SUBJECT: RIVER BEND STATION, UNIT 1 - AMENDMENT NO. 45 TO FACILITY  
OPERATING LICENSE NO. NPF-47 (TAC NO. 76851)

RIVER BEND STATION, UNIT 1

Amendment No. 45  
License No. NPF-47

SAFETY EVALUATION BY THE OFFICE OF NUCLEAR REACTOR REGULATION  
RELATED TO AMENDMENT NO. 45 TO FACILITY OPERATING LICENSE NO. NPF-47  
GULF STATES UTILITIES COMPANY  
RIVER BEND STATION, UNIT 1  
DOCKET NO. 50-458

FIGURE 3.4.6.1-1  
MINIMUM TEMPERATURE REQUIRED VS REACTOR PRESSURE

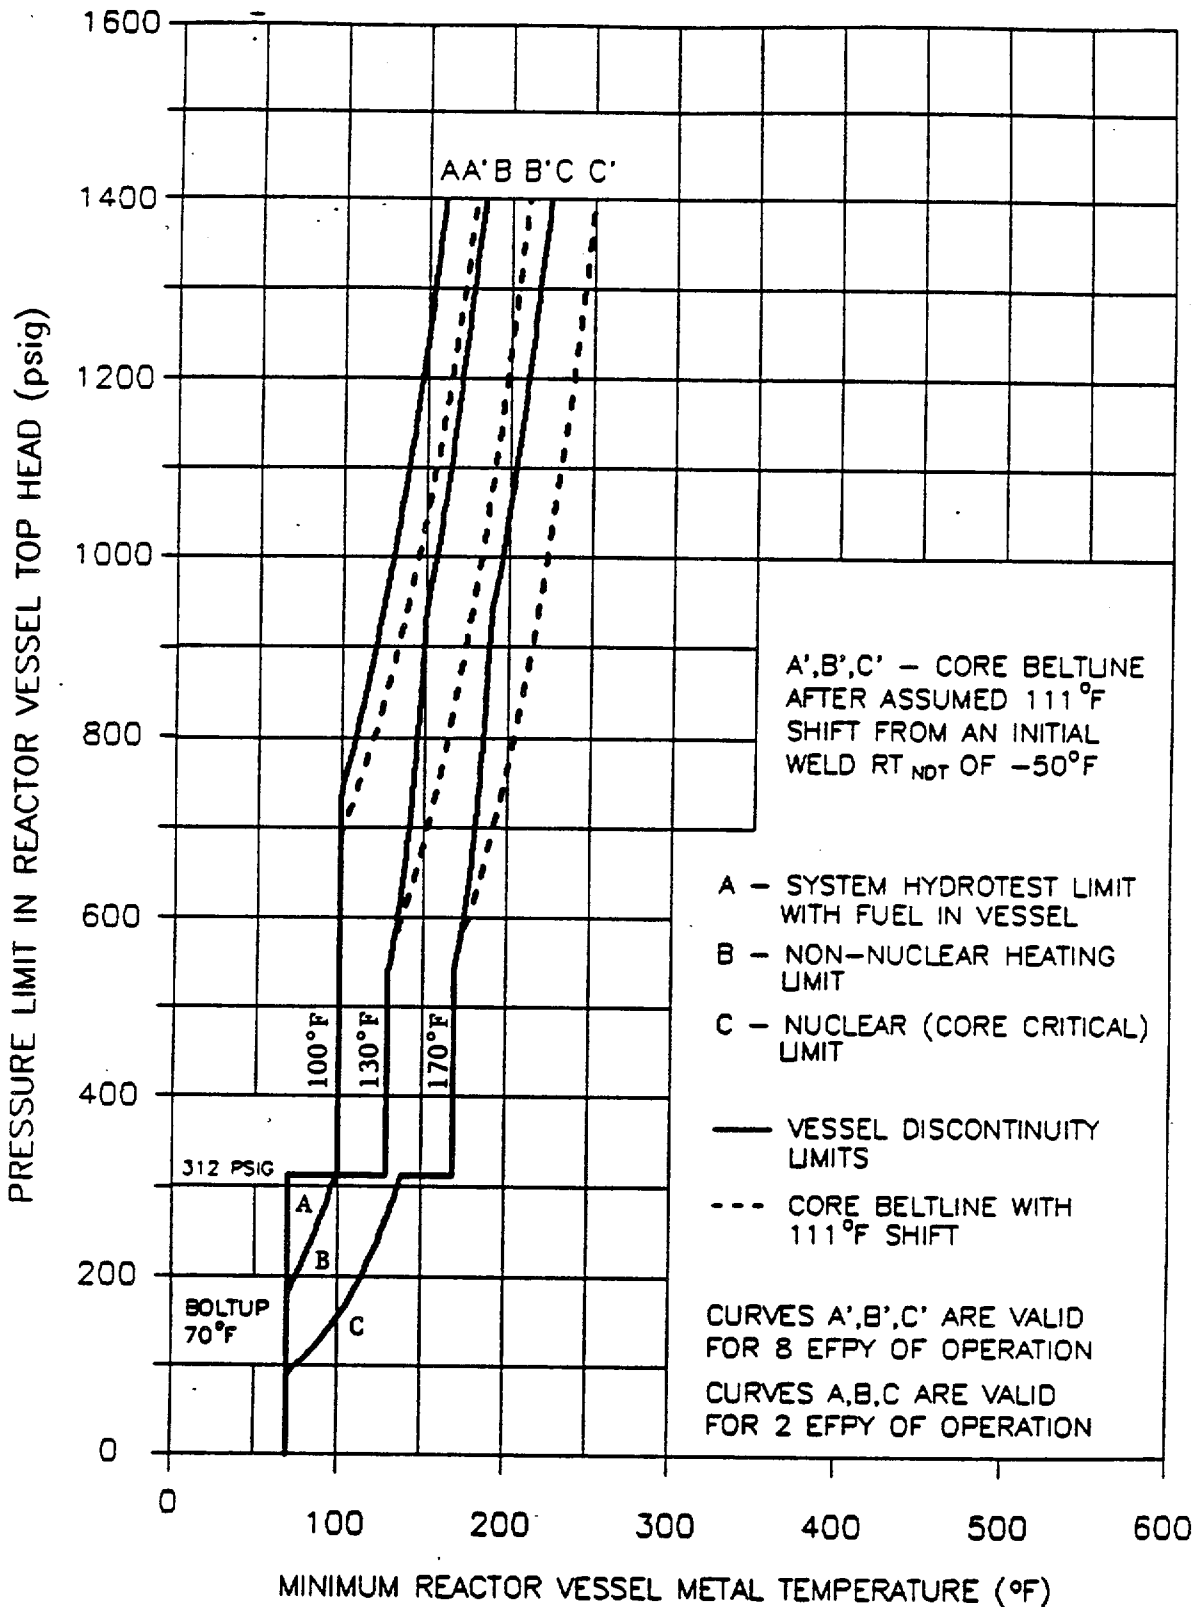
The amendment revises the "Minimum Temperature vs. Reactor Pressure" curves in TS 3/4.4.6 and the associated Bases. The changes were made in response to Generic Letter 88-11 which advised licensees to use the methods described in Revision 2 of Regulatory Guide 1.99 to predict the effect of neutron radiation on reactor vessel materials.

The pressure/temperature limit lines shown in Figure 3.4.6.1-1, curves C, and C', and A and A', for reactor criticality and for inservice leak and hydrostatic testing have been provided to assure compliance with the minimum temperature requirements of Appendix G to 10 CFR Part 50 for reactor criticality and for inservice leak and hydrostatic testing.

The staff evaluated the effect of neutron irradiation embrittlement on each beltline material in the River Bend reactor vessel. The amount of irradiation embrittlement was calculated in accordance with RG 1.99, Rev. 2. The staff determined that the material with the highest ART at 8 EFPY at 1/4T (T = reactor vessel beltline thickness) was weld 5P6756/0342 with 0.09 percent Cu (copper), 0.92 percent Ni (nickel), and an initial unirradiated  $RT_{ndt}$  (nil-ductility transition reference temperature) of  $-50^{\circ}\text{F}$ . At the 3/4T the limiting material was plate C3138-2 with 0.08 percent Cu, 0.63 percent Ni, and an initial unirradiated  $RT_{ndt}$  of  $9^{\circ}\text{F}$ .

For the limiting beltline material at 1/4T, weld 5P6756/0342, the staff calculated the ART to be  $60.8^{\circ}\text{F}$  at 8 EFPY. For the limiting beltline material at 3/4T, plate C3138-2, the staff calculated the ART to be  $42.6^{\circ}\text{F}$ . The staff used a neutron fluence of  $1.2\text{E}18 \text{ n/cm}^2$  at 1/4T and  $6.2\text{E}17 \text{ n/cm}^2$  at 3/4T. The ART was determined by Section 1 of RG 1.99, Rev. 2, because no surveillance capsule has been removed from the River Bend reactor pressure vessel.

The licensee used the method in RG 1.99, Rev. 2, to calculate an ART of  $60.5^{\circ}\text{F}$  at 8 EFPY at 1/4T for the same limiting weld metal. The staff judges that a difference of  $0.3^{\circ}\text{F}$  between the licensee's ART of  $60.5^{\circ}\text{F}$  and the staff's ART of  $60.8^{\circ}\text{F}$  is acceptable. Substituting the ART of  $60.8^{\circ}\text{F}$  into equations in SRP 5.3.2, the staff verified that the proposed P/T limits for heatup, cooldown, and hydrotest meet the beltline material requirements in Appendix G of 10 CFR Part 50.

The staff concludes that the proposed P/T limits for the reactor coolant system for heatup, cooldown, leak test, and criticality are valid through 8 EFPY because the limits conform to the requirements of Appendices G and H of 10 CFR Part 50. The licensee's submittal also satisfies Generic Letter 88-11 because the licensee used the method in RG 1.99, Rev. 2 to calculate the ART. Therefore, the proposed P/T limits are acceptable and may be incorporated into the River Bend Technical Specifications.

BASES FIGURE B 3/4.4.6-1  
FAST NEUTRON FLUENCE (E>1 MEV) AT VESSEL I.D.  
AS A FUNCTION OF SERVICE LIFE\*

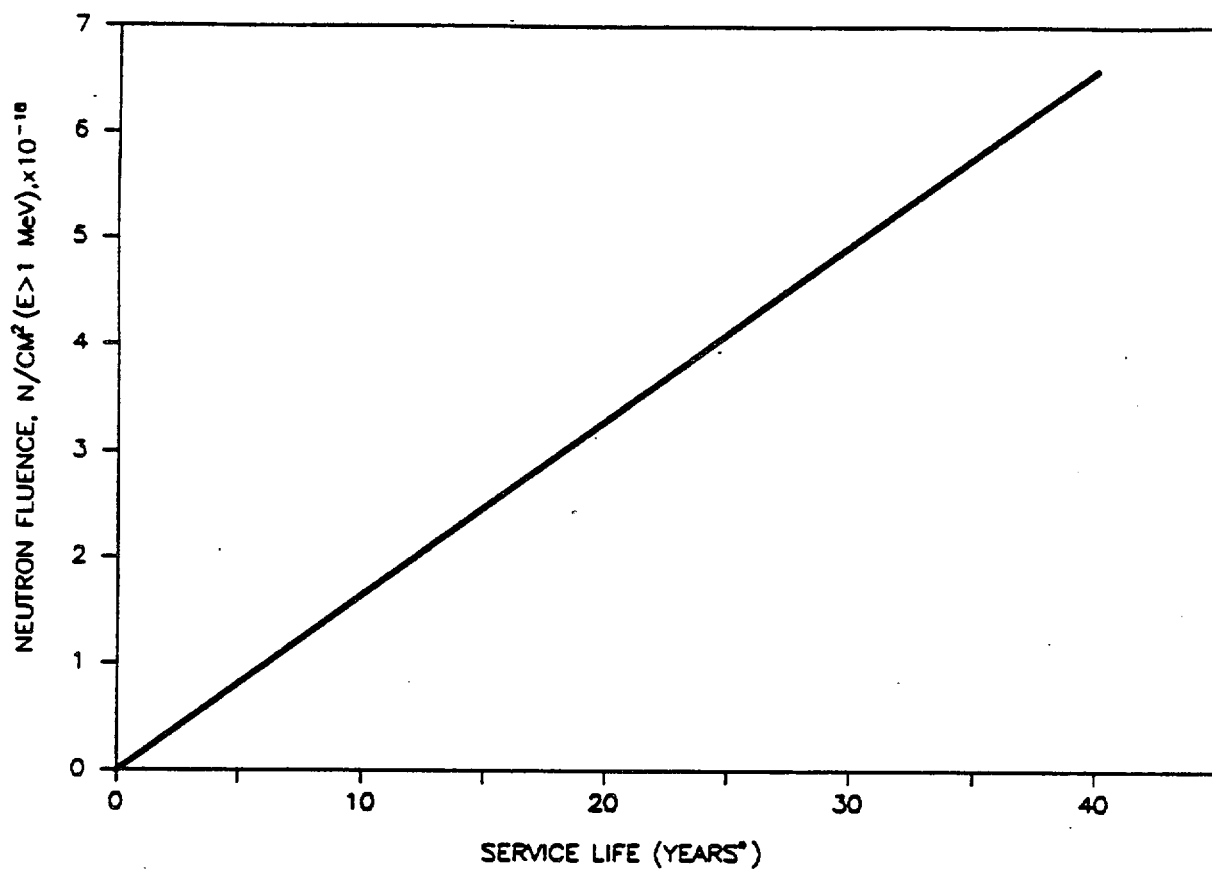
The reactor vessel materials have been tested to determine their initial  $RT_{NDT}$ . The results of these tests are shown in Table B 3/4.4.6-1. Reactor operation and resultant fast neutron (E greater than 1 MeV) irradiation will cause an increase in the  $RT_{NDT}$ . Therefore, an adjusted reference temperature, based upon the fluence, nickel content and copper content of the material in question, can be predicted using Bases Figure B 3/4.4.6-1 and the recommendations of Regulatory Guide 1.99, Revision 2, "Radiation Embrittlement of Reactor Vessel Materials." The pressure/temperature limit curve, Figure 3.4.6.1-1, curves A', B' and C', includes predicted adjustments for this shift in  $RT_{NDT}$  for the conditions at 8 EFPY.
